Subject: Issuance of Amendment No. 30 to Facility Operating License NPF-10
and Amendment No. 19 to Facility Operating License NPF-15
San Onofre Nuclear Generating Station, Units 2 and 3

Amendment No. 30
License No. NPF-10

Amendment No. 19
License No. NPF-15

SAFETY EVALUATION

FIGURE 3.1-3 Part Length CEA Insertion Limit Vs. Thermal Power

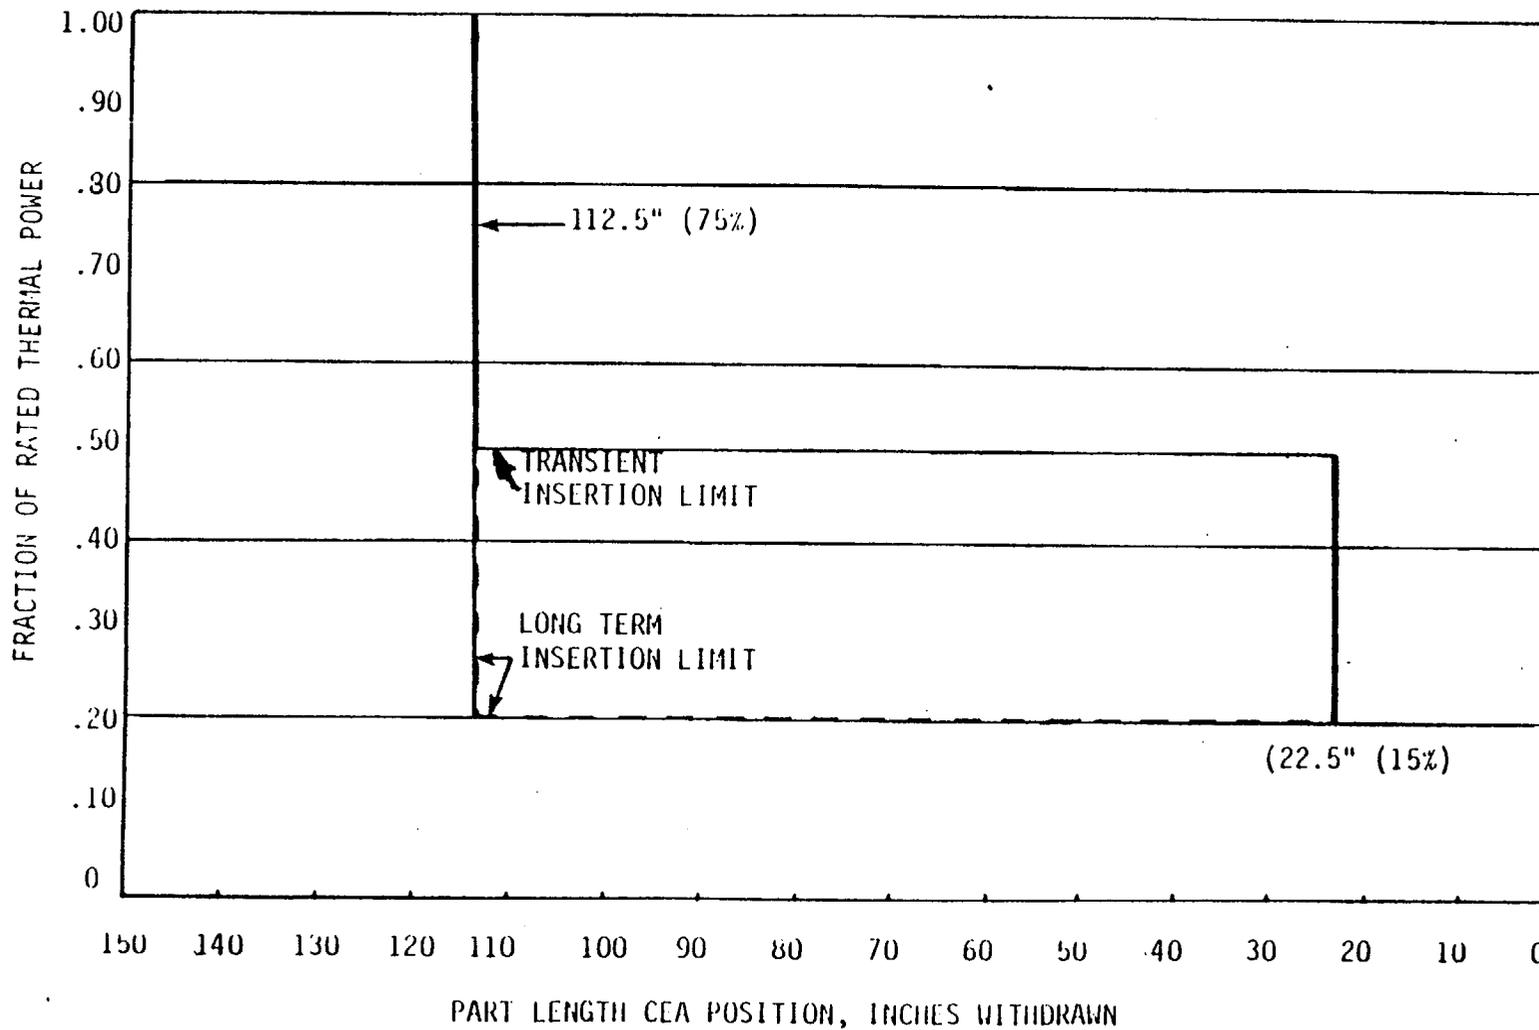
3.1.3.7 The position of the part length CEA group shall be restricted to prevent the neutron absorber section of the part length CEA group from covering the same axial segment of the fuel assemblies for a period in excess of 7 EFPD out of any 30 EFPD period. The position of the part length CEA group shall also be limited to the insertion limits shown in Figure 3.1-3.

The proposed change to Technical Specification 3.1.3.7 will restrict the part length CEA insertion to less than 25 percent for power levels greater than 50 percent of rated power as specified in the PDIL shown in the new Figure 3.1-3. The part length rods (PLR) are unique among the CEAs in that a PLR drop can cause a reactivity increase under the wrong set of circumstances. This reactivity increase will cause a temporary power excursion until the feedback mechanisms return the core to approximately its initial power. SCE has determined that the proposed restriction of PLR to less than 25 percent insertion will prevent a PLR drop from inserting positive reactivity for power levels above 50 percent of the rated power. For power levels below 50 percent, the long term insertion limit of 25 percent will still prevent a positive reactivity insertion on a PLR drop. However, operation between the long term and the transient insertion limits shown in Figure 3.1-3 could result in a

positive reactivity insertion on a PLR drop. The licensee provided an analysis to show that the ROPM available at those power levels is sufficient to accommodate a power increase from a PLR drop with positive reactivity insertion. We therefore conclude that the proposed change to Technical Specification 3.1.3.7 is acceptable.
